Re: **Tronox LLC (TRX) Facility**
Nevada Environmental Response Trust (Trust) Property
NDEP Facility ID #H-000539
Nevada Division of Environmental Protection (NDEP) Response to: *Phase 6 Groundwater Flow and Transport model*

Dated: November 27, 2019

Attachment 1

Figure 1. Groundwater levels in wells adjacent to Reaches 1 and 2 of the Las Vegas Wash. Data from Appendix E (Ramboll, 2019). Water level data for wells adjacent to other reaches of the wash are not included in Appendix E.

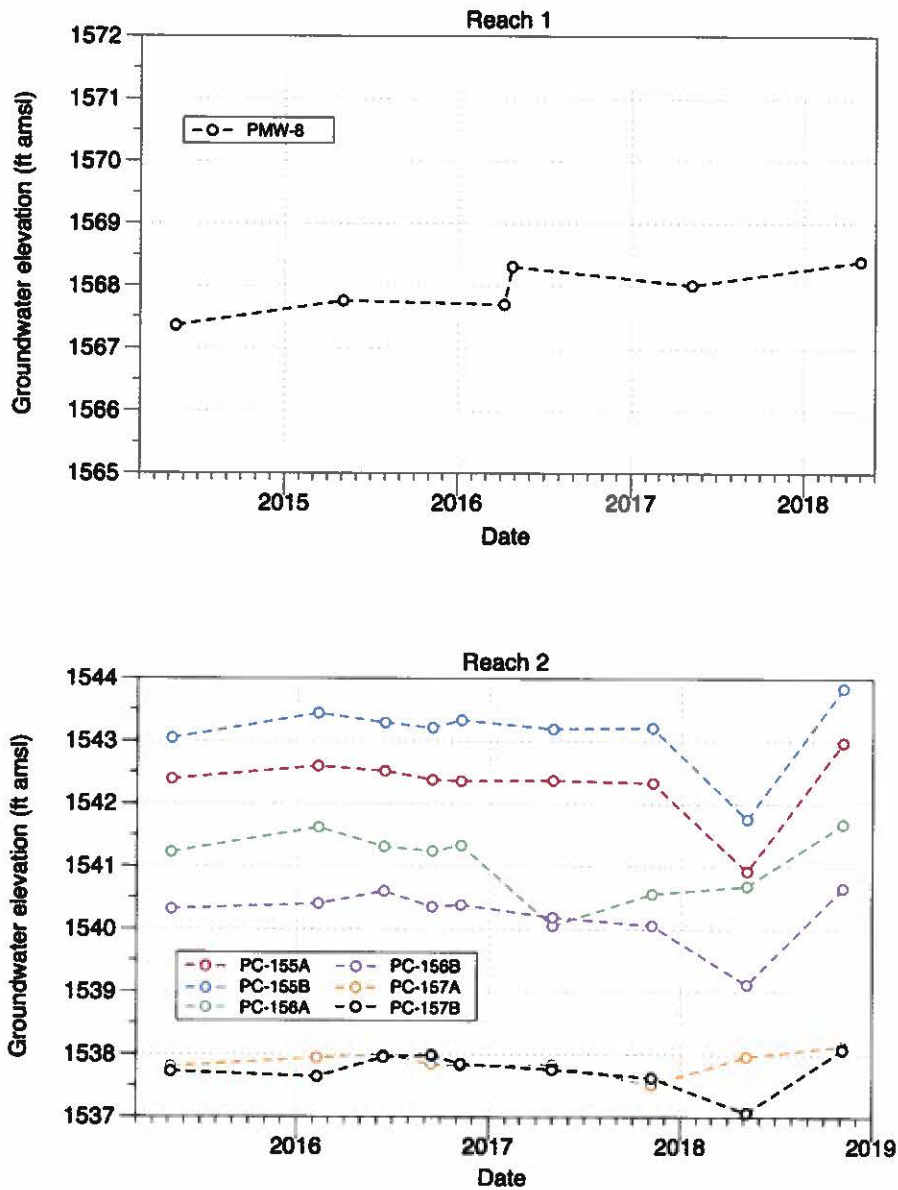
4. The results of an analysis of transducer data and an independent analysis by USGS of wash baseflow described in Section 3.1.5 (p. 16) and Figure 3-10 seem to contradict the net groundwater inflow rates estimated by the perchlorate mass flux method. This reach is presented as having a positive net groundwater inflow, while these analyses suggest that the wash is a losing stream here. Please address this discrepancy in next phase model.

25. Section 3.1.5. The result of the transducer analysis indicates that the Wash is a losing stream in Reach 3. This appears to contradict the analysis of groundwater discharge to Reach 3 from the perchlorate mass loading analysis, which indicates that Reach 3 gained a relatively small volume of water. It is suggested that the potential contradiction between the transducer and perchlorate mass loading analyses be further explored and that further justification be provided for identifying Reach 3 as a gaining stream versus a losing stream.

Figure 2. Observed and simulated vertical hydraulic gradients in the middle and deep zones of the flow model in Quarter 4 of 2014.

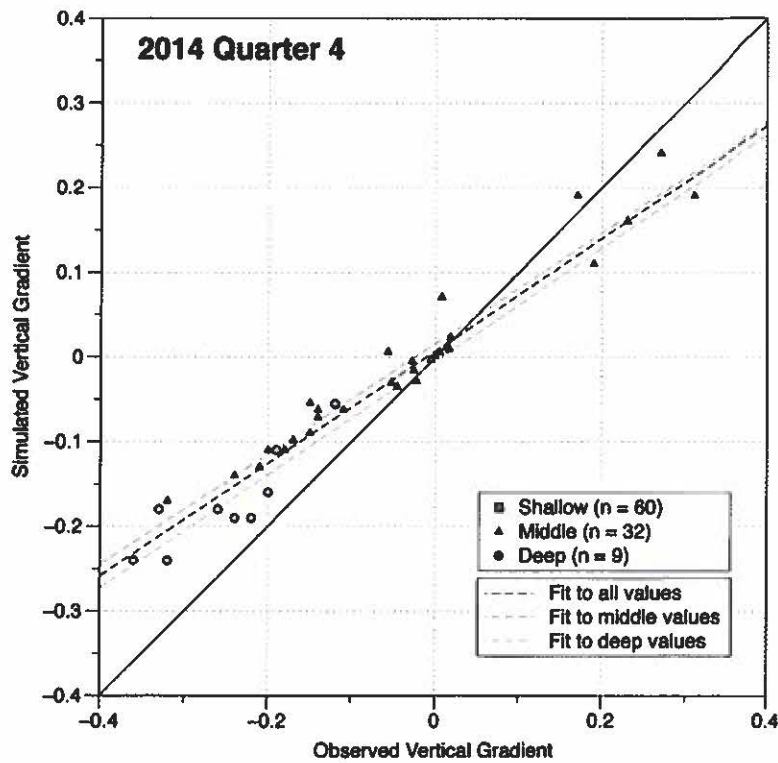
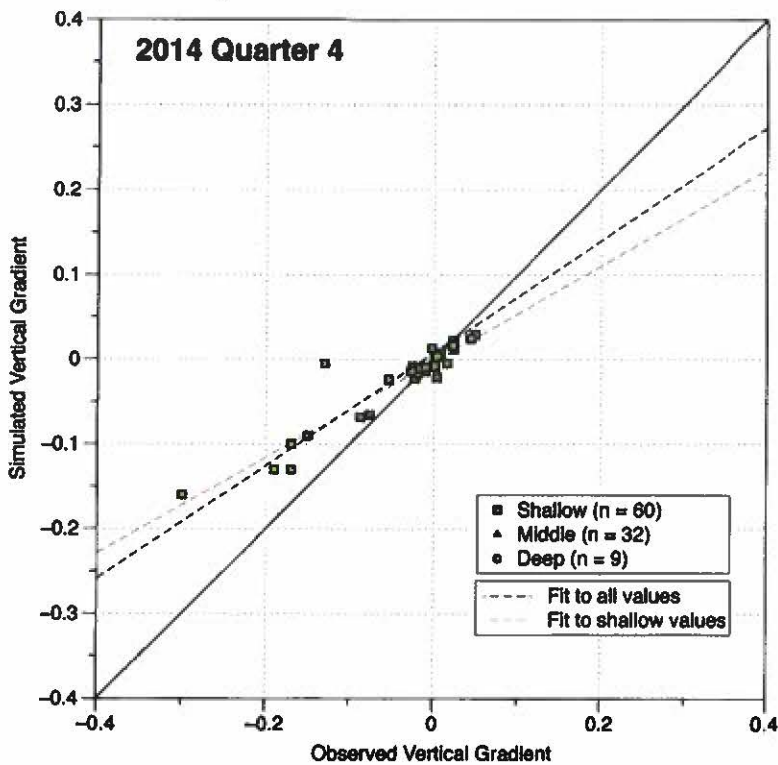
- d. Although simulation of heads has improved in the Phase 6 model, the simulation of vertical hydraulic gradients remains a challenge. The conclusion that Figure 6-5 demonstrates an “acceptable fit except a few outliers” is an incomplete presentation of the results, especially because “acceptable” is not defined. As shown in attached Figure 2, all of the measured vertical gradients in the deep zone, which all direct flow upward, are under-predicted by the model. In addition, gradients at over half of the measurement locations in the middle zone that indicate upward flow, are also under-predicted. Although most simulated gradients in the shallow zone show little bias, all of the observed upward gradients are under-predicted by the model (attached Figure 3). Most of these points are located in the NERT source area and source areas to the west, as shown in attached Figures 4 and 5. In combination with the relative small difference in hydraulic conductivity of the alluvium, UMCf-cg, and UMCf-fg, these vertical gradients may have an important influence on movement of perchlorate from the release sites into the underlying units and their accurate simulation is critical to the success of the transport model.

Figure 4. Observed vertical hydraulic gradients in the middle and deep zones. Observed values are identified by black labels and model-simulated values are identified by red labels.

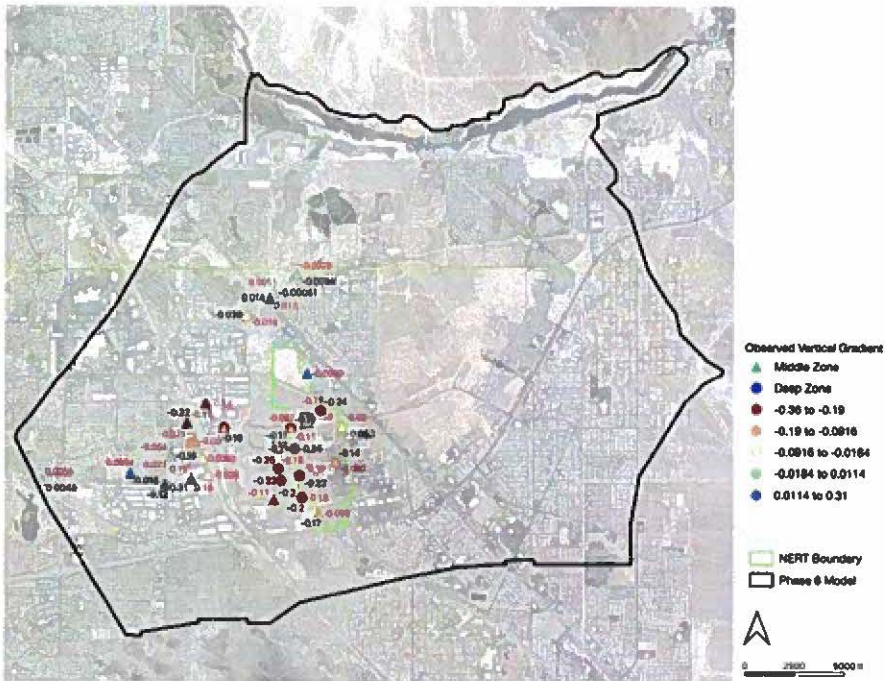
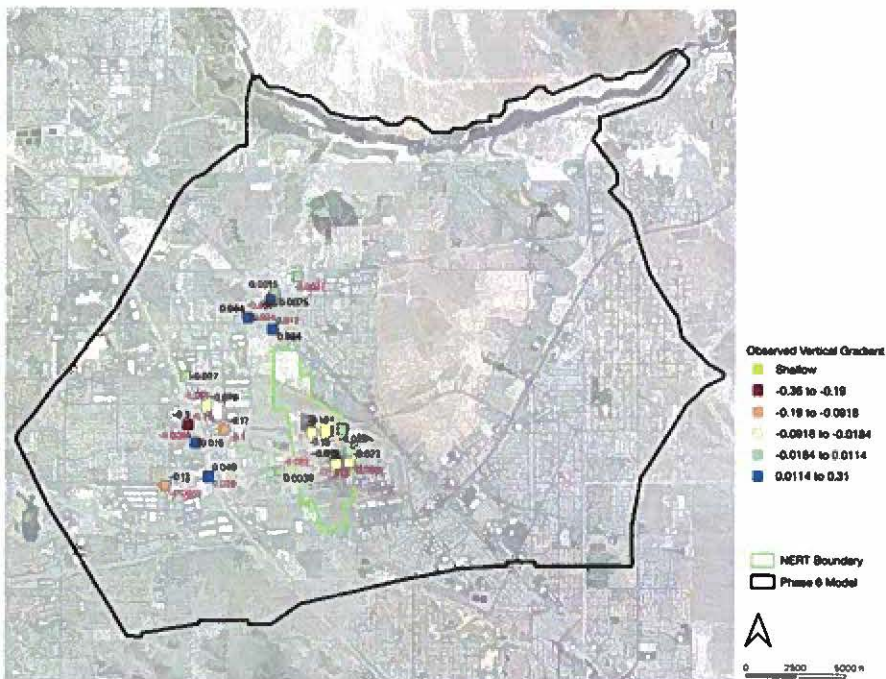
8. The vertical gradients may have an important influence on movement of perchlorate from source areas, and the accurate simulation of vertical gradients is critical to the success of the transport model. Therefore, for the Phase 7 Model, it is recommended that bottom boundary condition be further evaluated with respect to upward groundwater flow from depth and that justification be provided for the selection of the bottom boundary condition. In addition, as described in Section 3.2, the match to observed vertical gradients based on actual simulated groundwater elevations shows room for improvement, and revising the bottom boundary condition from no flow to specified flux, for example, may help in this regard in developing the Phase 7 Model.

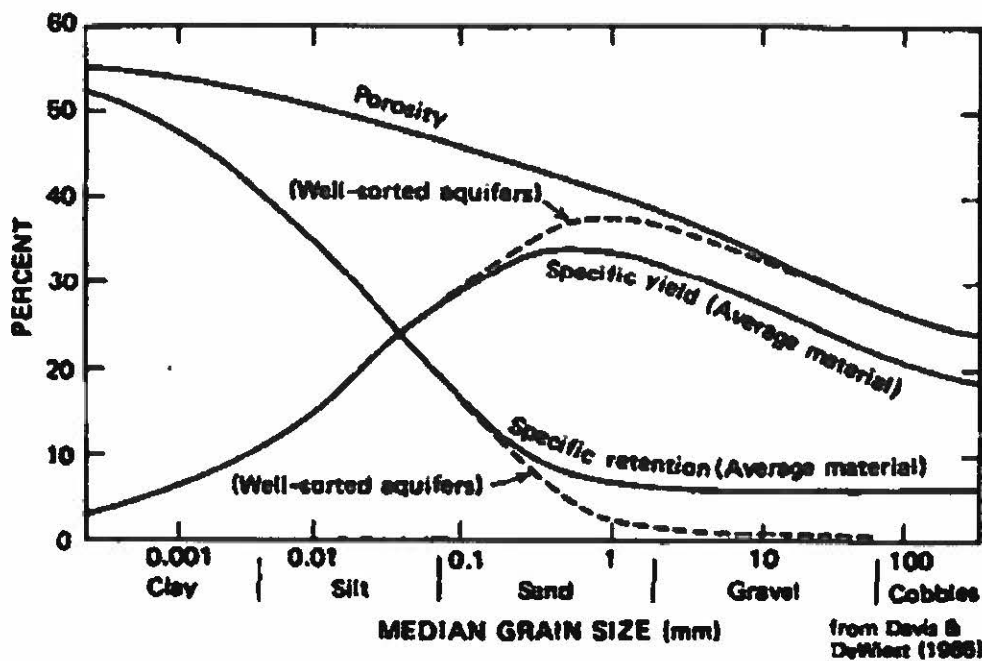
The model contains sharp contrasts between paleochannel, wash area, and alluvium hydraulic conductivity zones. Based on the cross sections shown in the Seep Well Field Area Bioremediation Study, the changes are more likely to be gradational than sharp, however. While the paleochannels

are likely to cause preferential flow to occur, the sharp contrasts may cause more channelization of the flow within the model than actually occurs in these areas.
